Linden Avenue Assisted Living Facility | 2nd Early Design Guidance
13524 Linden Avenue N
DPD Project #3020289

Design Review Board Recommendations & Response

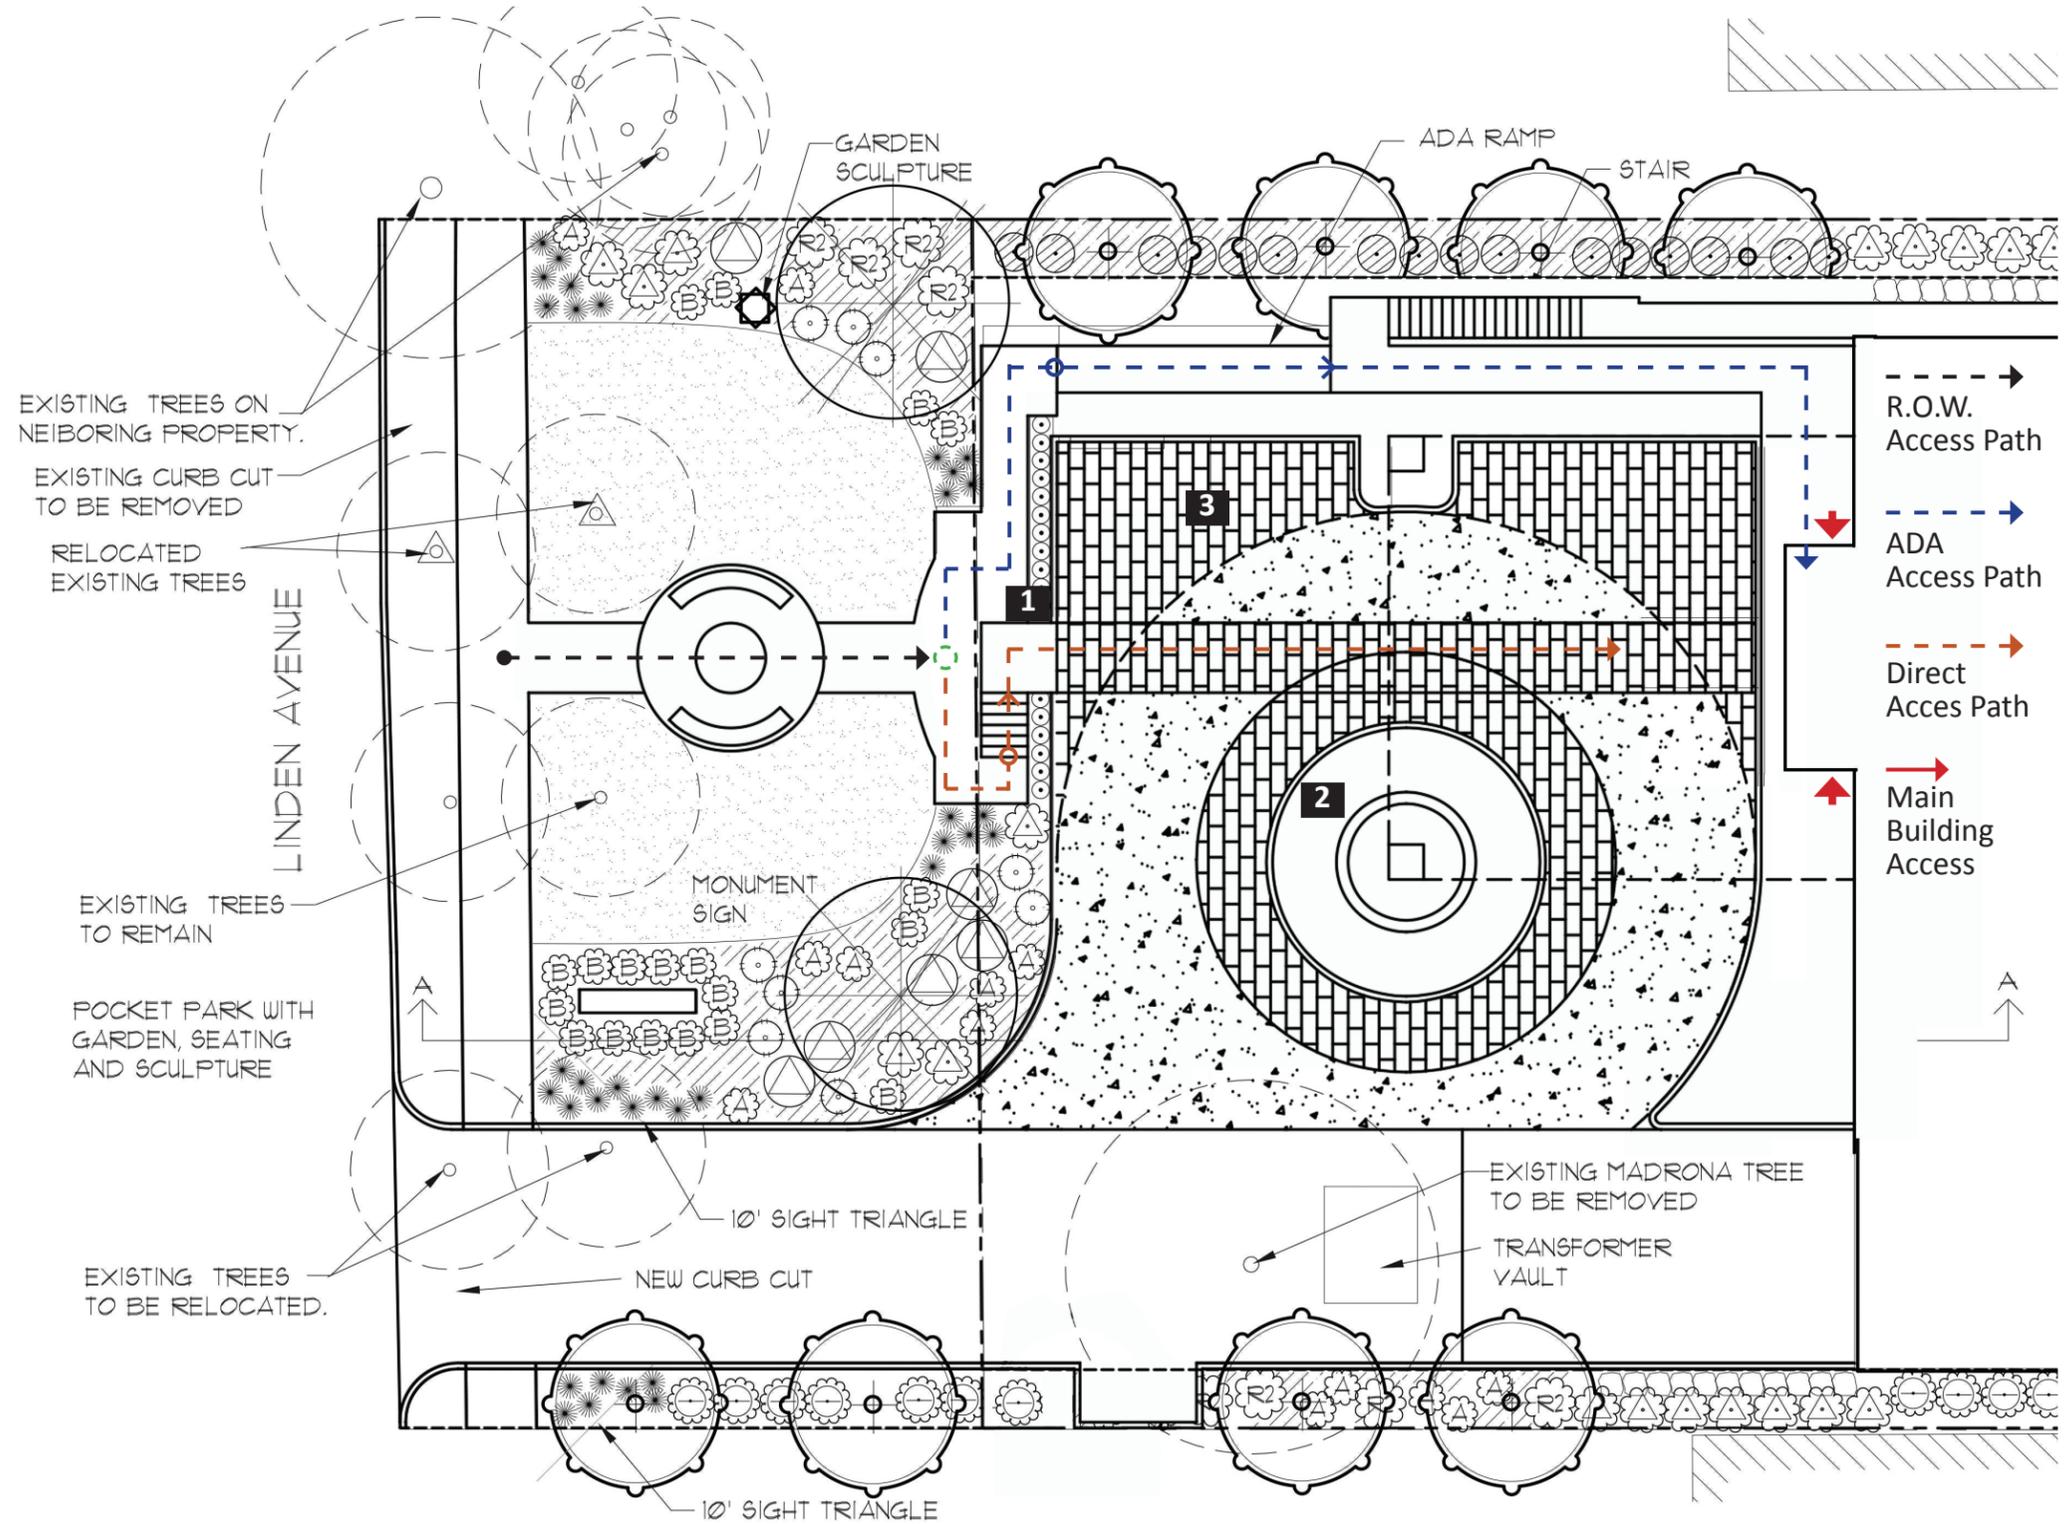
2b. Accessibility and the pedestrian experience should be a priority. If parking is to be located between the entry and the front setback amenity space, a direct pedestrian-oriented path between the sidewalk, front setback amenity space and building/primary entry, should be included. (PL4-A-1, PL4-A-2, DC1-B-1, PL2-A-1, PL2-A-2)

- A slow-moving traffic drop-off circle integrated with a landscape island, has been instituted to enhance pedestrian walkable experience.
- A direct access path surfaced with concrete pavers connects the R.O.W. and the Porte Cochere entry. Another concrete path near north edge of the site offers wheelchair access opportunity.
